JAF-18-0086
NMP1L3235

August 31, 2018

Calvert Cliffs Nuclear Power Plant, Units 1 and 2
Renewed Facility Operating License Nos. DPR-53 and DPR-69
NRC Docket Nos. 50-317 and 50-318

Subject: License Amendment Request for Approval of Changes to Emergency Plan
Staffing Requirements

FIGURE 2-1
MINIMUM ON-SITE STAFFING
REQUIREMENTS

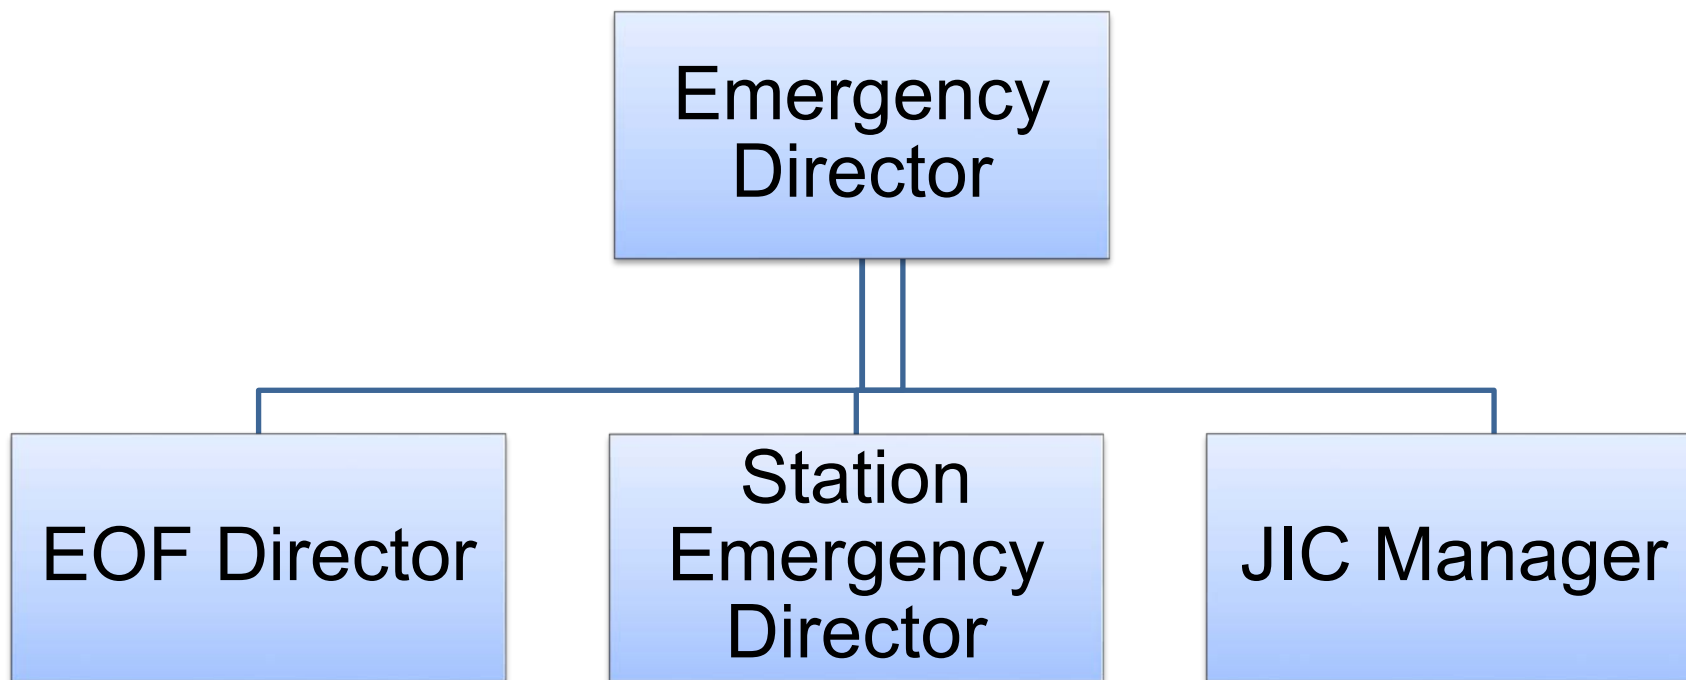
2.1.1 The content and format of the Calvert Cliffs Emergency Plan Annex EP-AA-1011, Figure 2-1, "*Minimum On-Site Staffing Requirements*," will be revised to align with the NRC's Alternative Guidance. This includes revisions to the EP Functions and Major Tasks, as well as the Minimum Staff assigned to these areas. The proposed changes will result in a change in some designated Minimum Staff responders and the relocation of the Full Augmentation staff from the Emergency Plan to Calvert Cliffs EPIPs, consistent with the NRC's Alternative Guidance.

The Calvert Cliffs on-shift staff will align with the NRC's Alternative Guidance. The proposed changes to align the Calvert Cliffs Emergency Plan Annex EP-AA-1011, Figure 2-1 with the NRC's Alternative Guidance for the on-shift ERO are described as follows:

The proposed revision also removes the Chemistry personnel from Figure 2-1. The Chemistry/Radiochemistry function listed in Table B-1 to Revision 1 of NUREG-0654, is no longer needed as the need for immediate reactor coolant sampling has been reduced due to the variety of available plant indications of fuel damage available at Calvert Cliffs. Early indications of fuel damage can be identified through Containment Radiation Monitors, Core Instrumentation, or Effluent Radiation Monitors, all of which are available in the MCR.

The proposed revision also removes the one (1) Minimum Staff Chemistry Technician from Figure 2-1. The Chemistry/Radiochemistry function listed in Table B-1 to Revision 1 of NUREG-0654 is no longer needed as the need for immediate reactor coolant sampling has been reduced due to the variety of available plant indications of fuel damage available at Calvert Cliffs. Early

The Calvert Cliffs Emergency Plan Figure 2-1 does not currently specify a separate Emergency Classification Function for the On-shift Staff. Calvert Cliffs proposes to revise Emergency Plan Figure 2-1 to align with the NRC’s Alternative Guidance. This function is assigned to a pre-existing on-shift staff member as a collateral duty (e.g., STA). The STA has the experience and training to fill this position and the responsibilities for monitoring plant operation are consistent with the EP position responsibilities. The STA is trained in EAL classification and is available in the MCR to evaluate plant conditions and recommend emergency classifications as described in the NRC’s Alternative Guidance.

FIGURE 2-2
Emergency Response
Organization

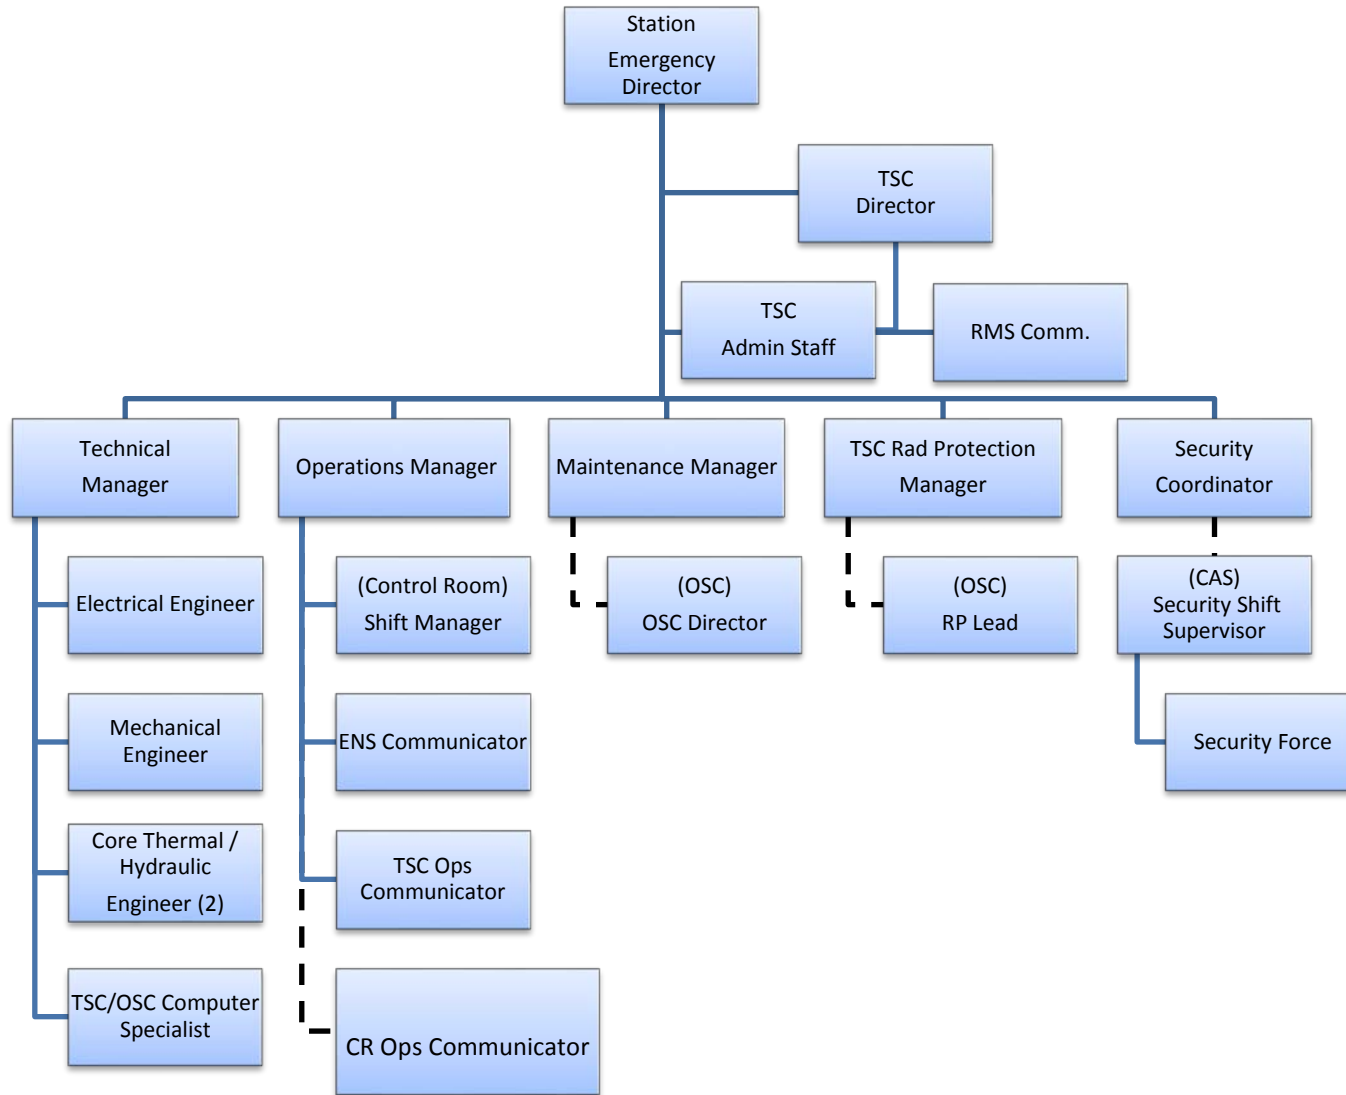
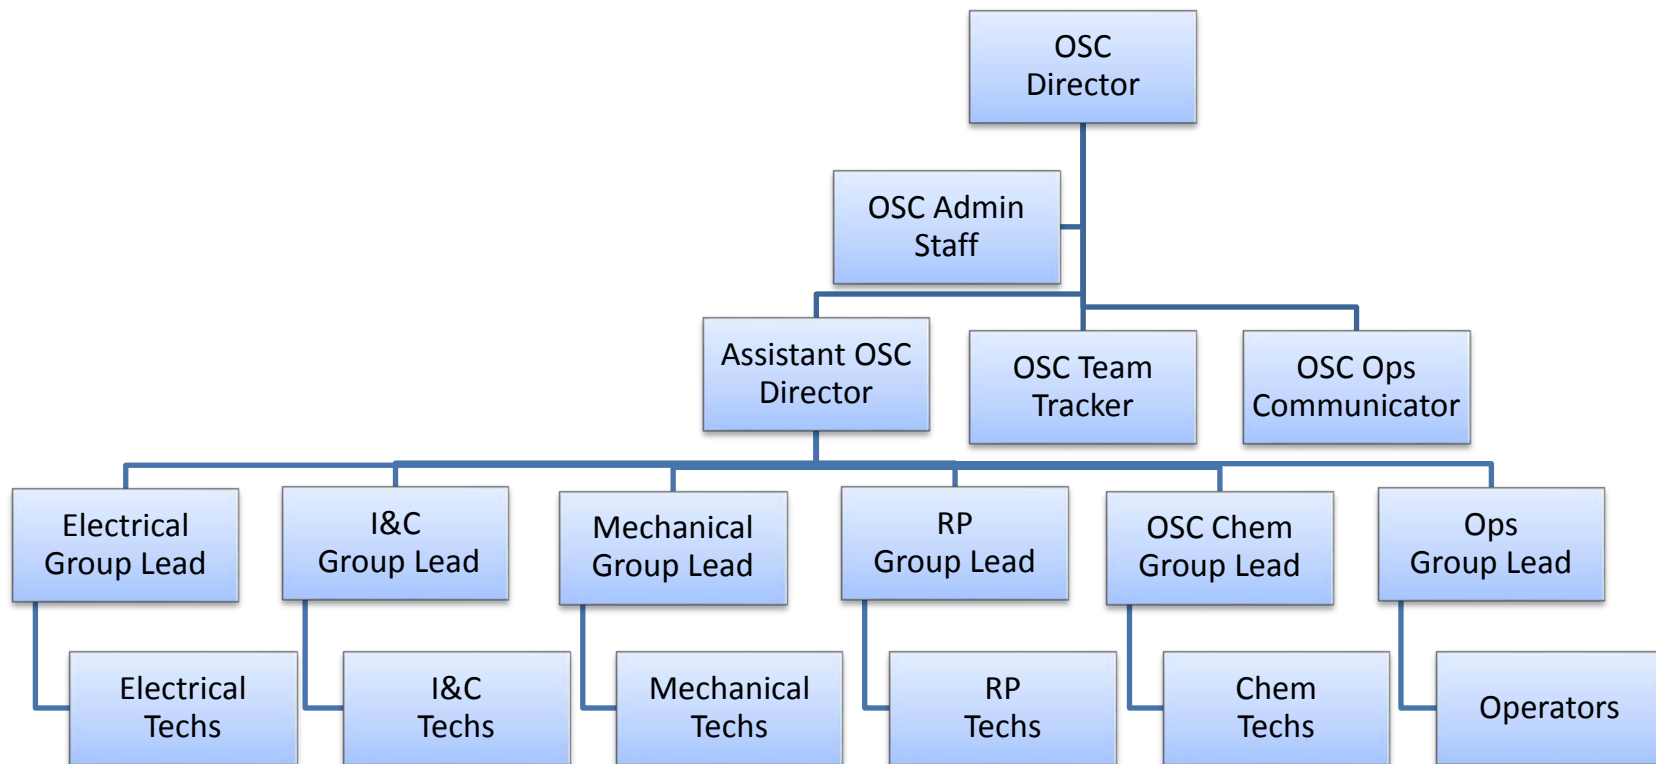
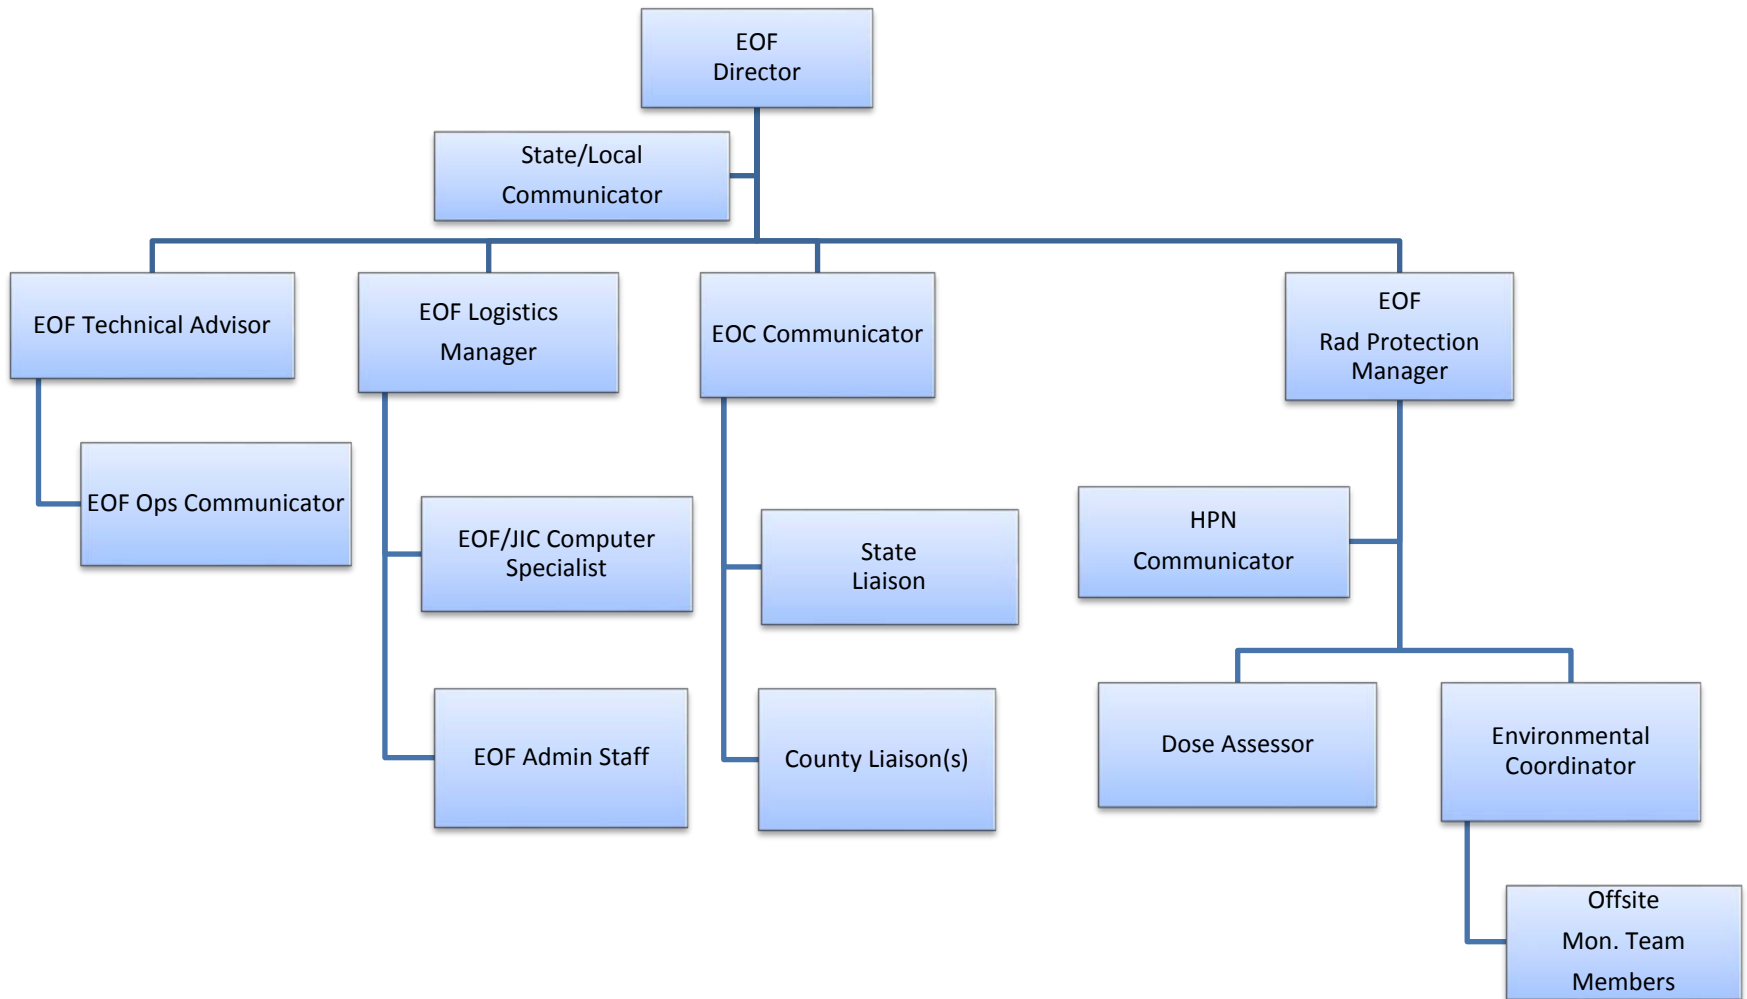
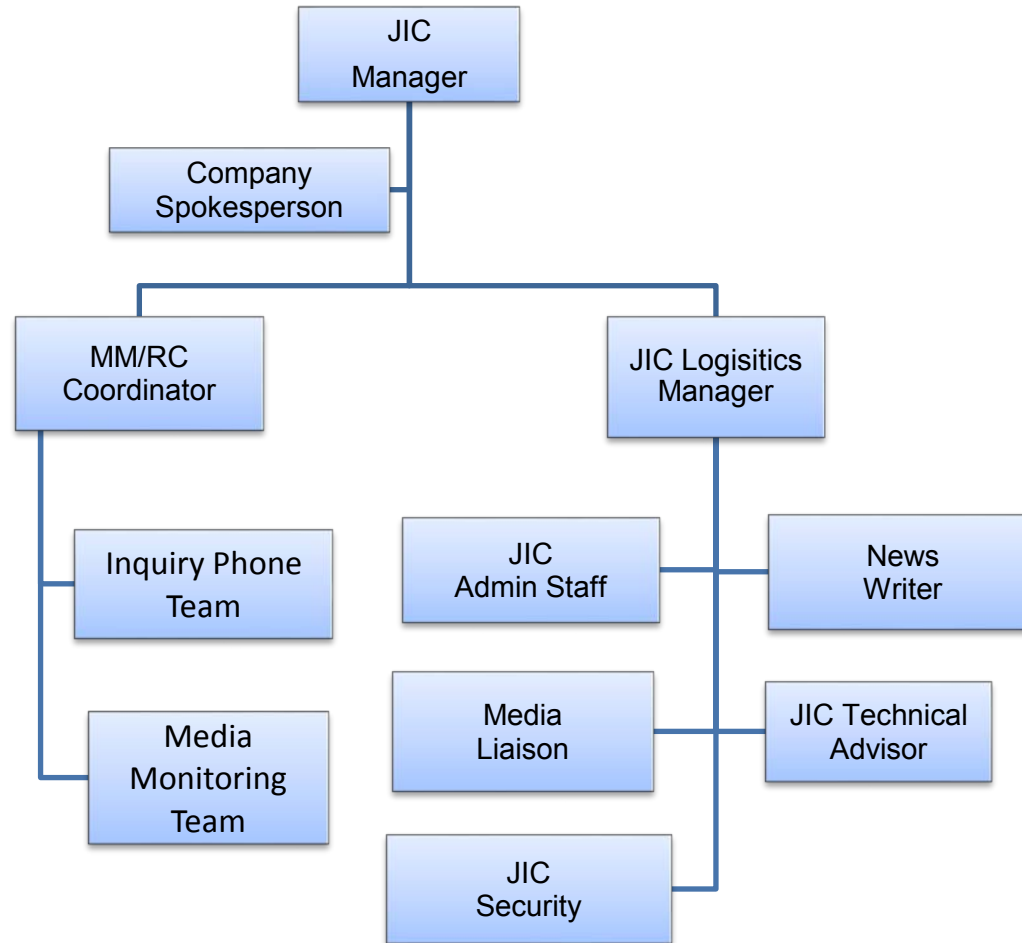
The proposed changes will also relocate the identified Full Augmentation ERO specified in the Calvert Cliffs Nuclear Power Plant Emergency Plan Annex EP-AA-1011, Figure 2-2, "*Emergency Response Organization*" to an Emergency Preparedness Implementing Procedure (EPIP).
